**AGENDA**  
**City of Monona Plan Commission**  
**Monona Public Library - Municipal Room**  
**1000 Nichols Road, Monona, WI**  
**Monday June 27, 2016**  
**7:00p.m.**

**PLAN COMMISSION STAFF REPORT  
CITY OF MONONA**

Enclosed is the revised existing, site, and grading/erosion control plan set for The Kilgust Drive Building Addition for Wiedenbeck, Inc. The plans have been revised to address comments contained in your letter dated June 7<sup>th</sup>. The responses to comments are as follows:

**2451 KILGUST ROAD BUILDING ADDITION**  
 UTILITY PLAN  
 SHEET: C-4  
 DATED: JUNE 17, 2016

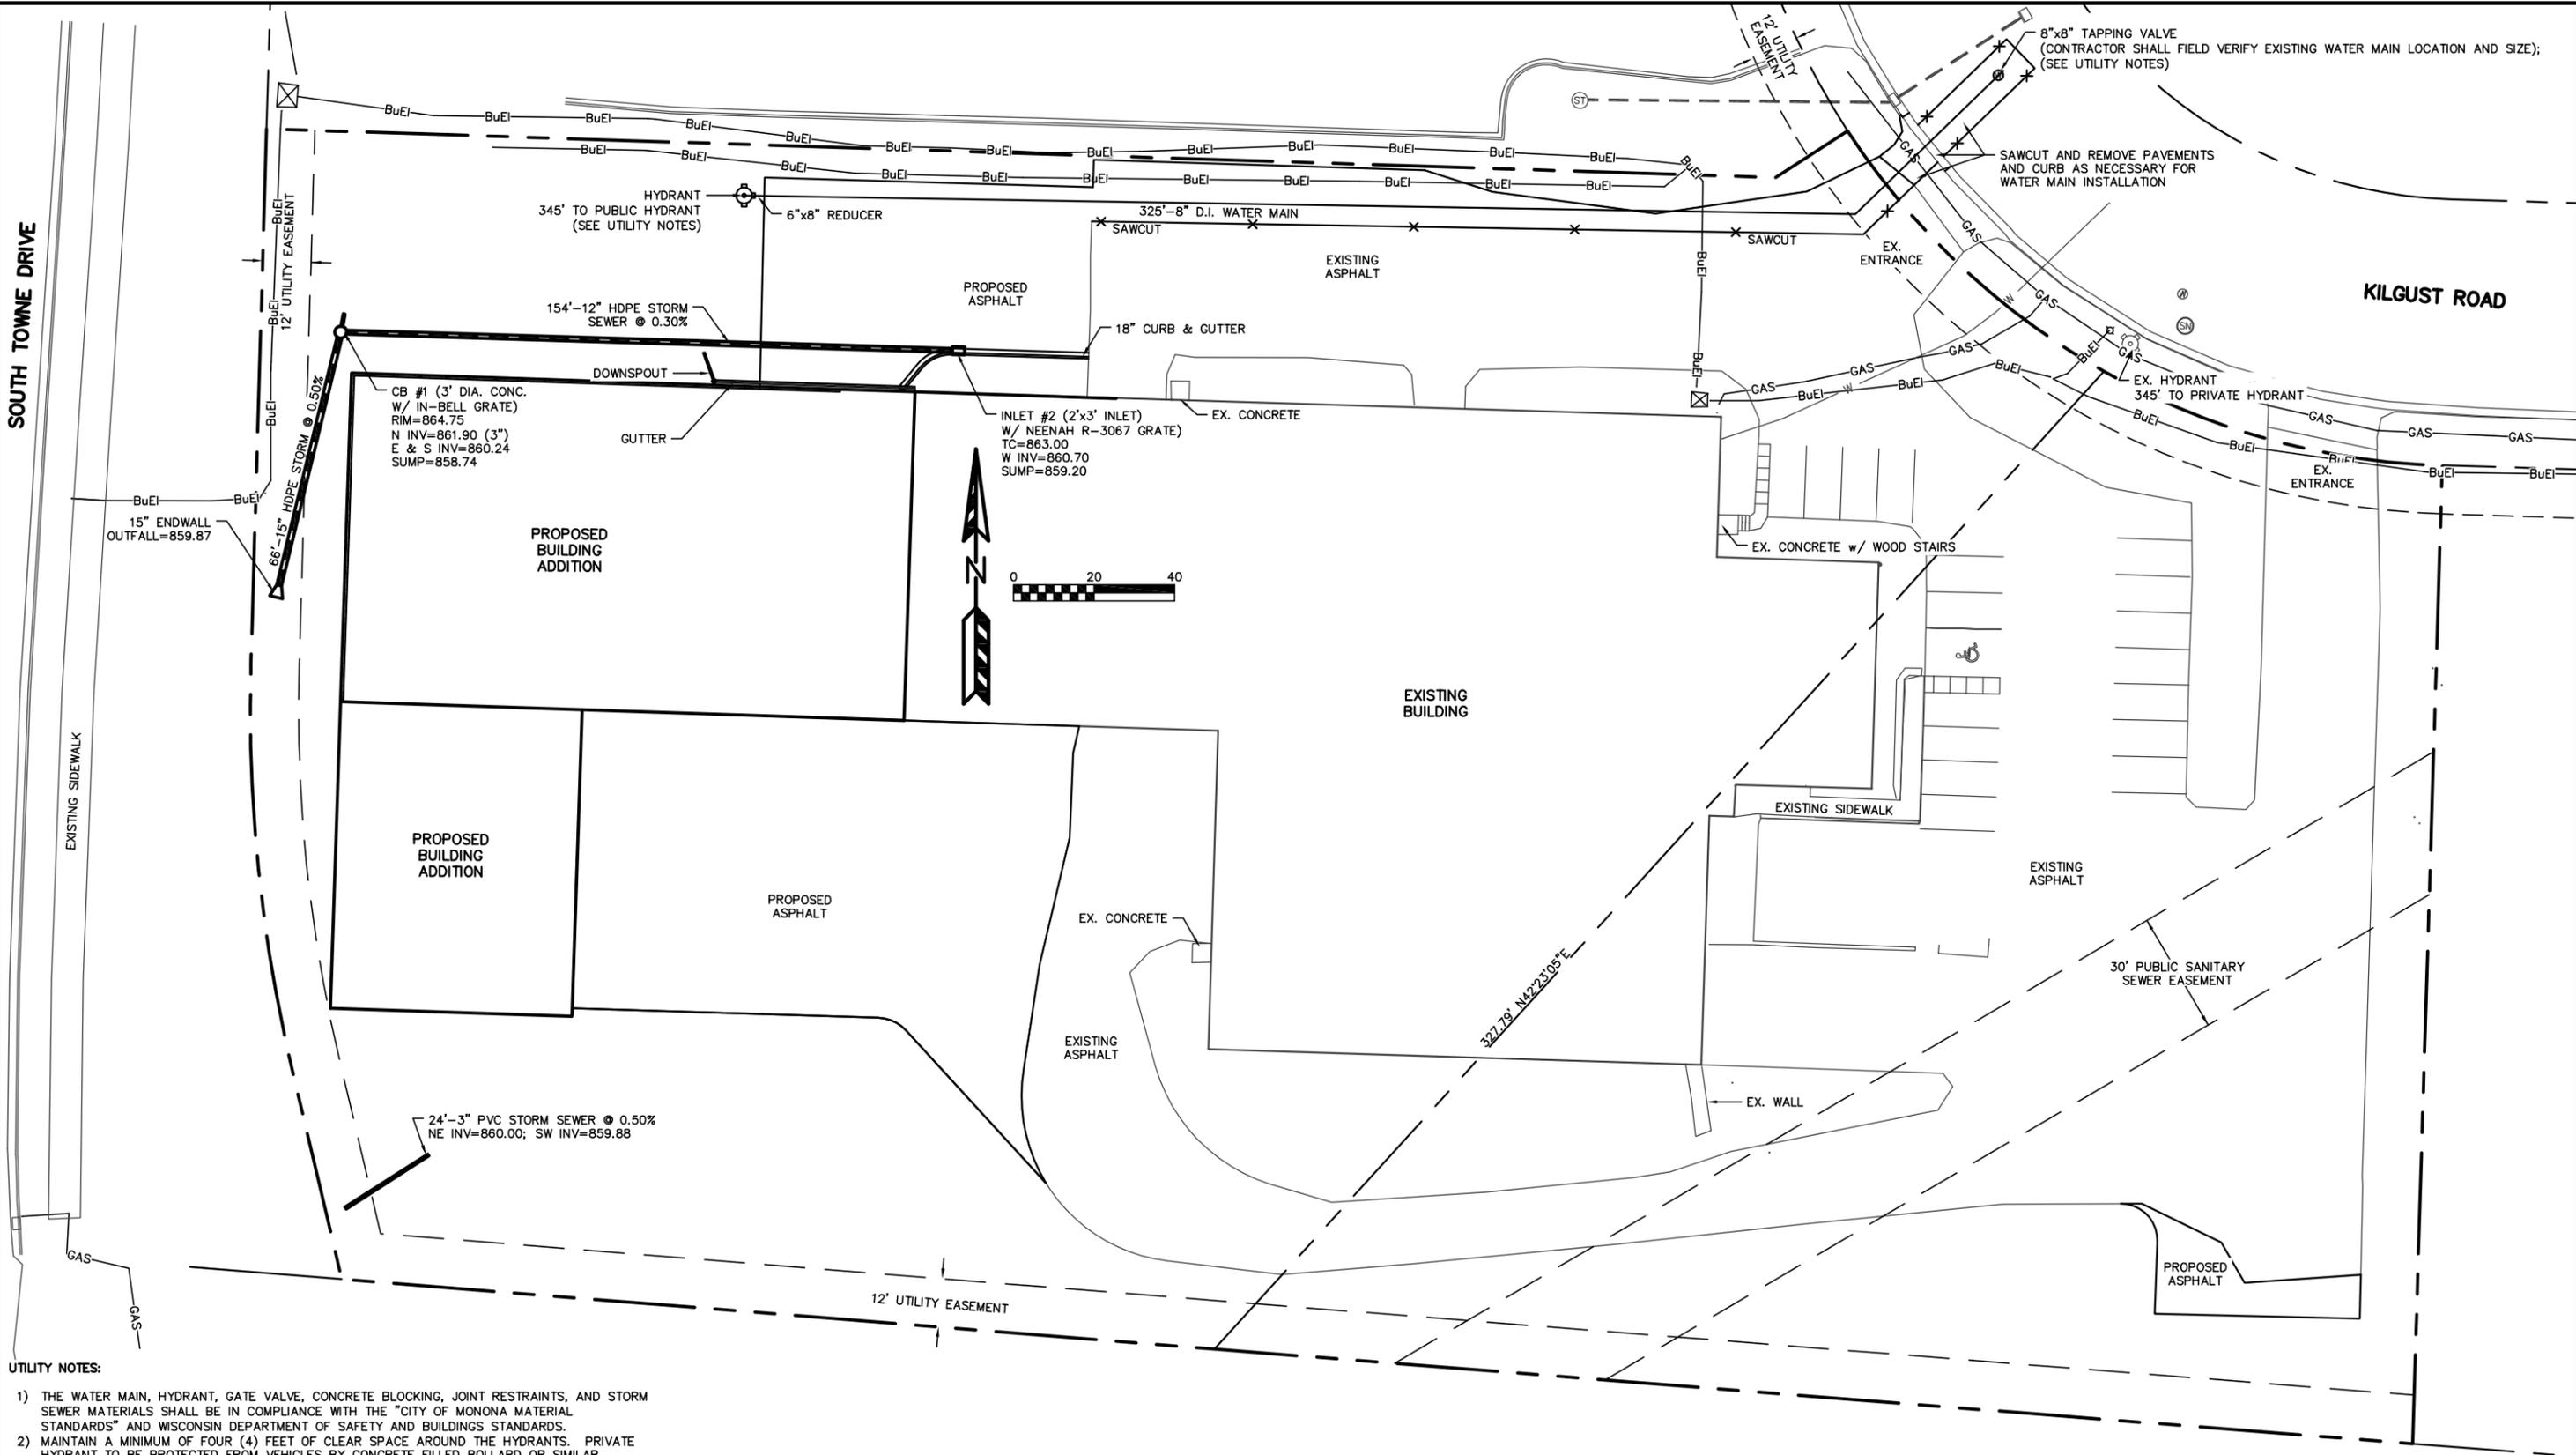
- Addition of a private hydrant is required. The location is shown on the utility plan. The utility plan shows the lateral being tapped into the water main with an 8" pipe, however, the Fire Chief has authorized a 6" pipe tapped into the existing lateral. If for some reason the pipe is tapped in Kilgust then City of Monona patching standards and a ROW permit shall apply.

- *Existing and/or proposed private hydrants on the site should be shown on the plan.*

- A private fire hydrant is needed - A hydrant has been added to the Utility Plan and Scott Sullivan, Monona Fire Chief, is allowing a variance for 6" pipe instead of 8" and is allowing us to tap into the existing lateral.

**The existing and proposed hydrants are included on the attached Utility Plan.**

**2451 KILGUST ROAD BUILDING ADDITION**  
 GRADING AND EROSION CONTROL PLAN  
 SHEET: C-3  
 DATED: JUNE 17, 2016

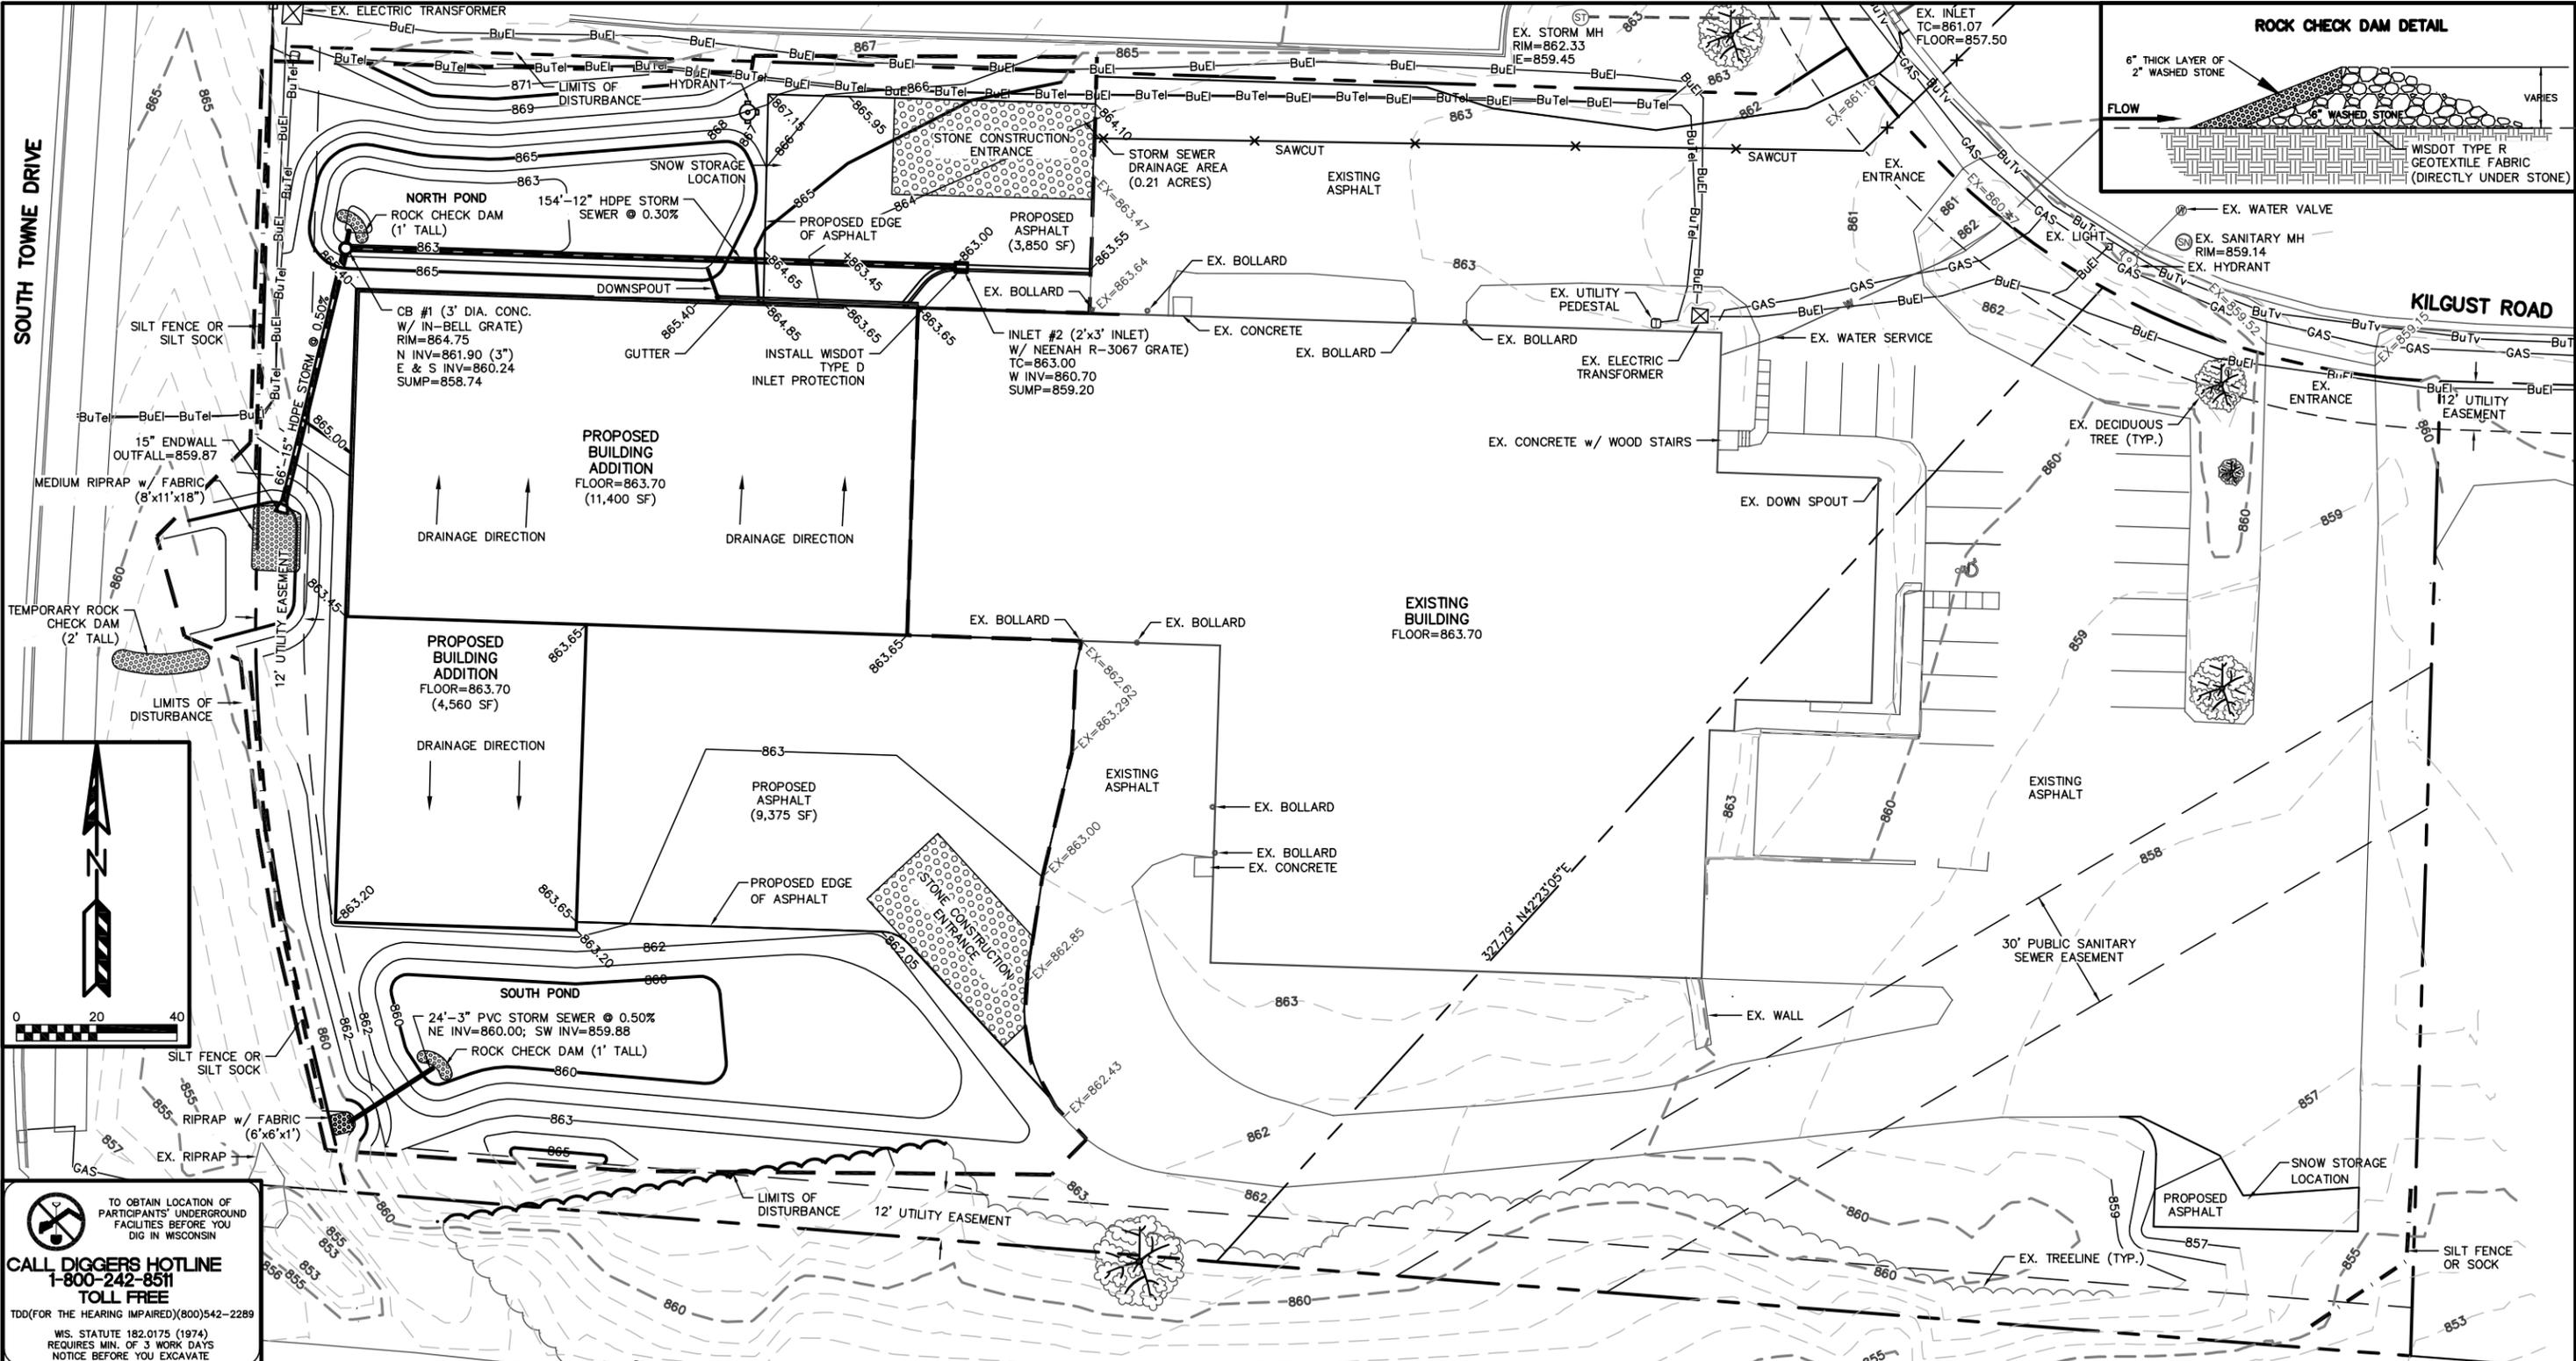
- *The proposed conditions pervious and impervious areas as well as the percent impervious area should be indicated on the "Grading & Erosion Control Plan".*

- *The 867 contour crosses the 866 & 865 contours just west of the north overhead door of the proposed addition. The grading plan should be revised to eliminate these contours from crossing.*

- *There is a drainage swale just north of the proposed addition that has segments with 1.5%, 0.86% and 1% slopes. It is recommended that the spot elevations and contours along this swale be changed to provide a uniform slope equal to at least 1%.*

- *The plans show a proposed spot elevation of 860.00 at the southwest end of the proposed 12" HDPE storm sewer. This elevation is two feet lower than the existing elevation at this location. Additional grading will be required to facilitate drainage from this proposed storm sewer. Also, the end of this storm sewer appears to be proposed in the South Towne Drive right-of-way. It is recommended that proposed private storm sewer and grading be located on the owner's parcel and not in the city's right-of-way.*

- *There is a proposed drainage swale south of the south proposed building addition with a slope of 0.86%. It is recommended that the slope of this swale be revised to at least 1% to provide adequate drainage.*

- *The storm sewer manhole and curb inlet notes should be revised to include sumps with an 18" minimum depth per the "City of Monona Material Standards".*

- *The plans should be revised to show an endwall at the proposed storm sewer discharge.*

- *The Stone Construction Entrance detail should be changed to show a minimum width of 24 feet (the full width of the egress point), and WisDOT Type R geotextile fabric underling the stone tracking pad per the "Stone Tracking Pad" requirements of the Dane County Erosion Control and Stormwater Management Manual.*

- *There is a gap in the silt fence/silt sock along the west side of the property. The plans should be revised to show a continuous span of silt fence or silt sock along the west property line.*

**Pervious, impervious, and percent impervious area notes have been added to the Grading & Erosion Control Plan.**
- *The submitted erosion control and stormwater management permit application mentions that five new parking spaces are proposed. However, the plans do not show the proposed parking stalls. The plans should be revised to show the locations and dimensions of the proposed parking stalls.*

**The contours in this location have been revised.**

**The contours in this area have been revised to incorporate the North Pond.**

**The storm sewer has been rotated to be within the owner's parcel. Contours have been added to show the grading at the outfall.**

**The contours in this area have been revised to incorporate the South Pond.**

**The Grading and Erosion Control Plan has been revised to include an 18" sump for catch basin #1 and inlet #2.**

**The Grading and Erosion Control Plan has been revised to include an endwall.**

**The Grading and Erosion Control Plan and detail have been revised to show the stone construction entrance having geotextile fabric underlying the stone and a width of 24 feet.**

**The silt fence has been extended to show a more continuous span. A rock check dam is shown at the storm sewer outfall in lieu of silt fence/sock.**
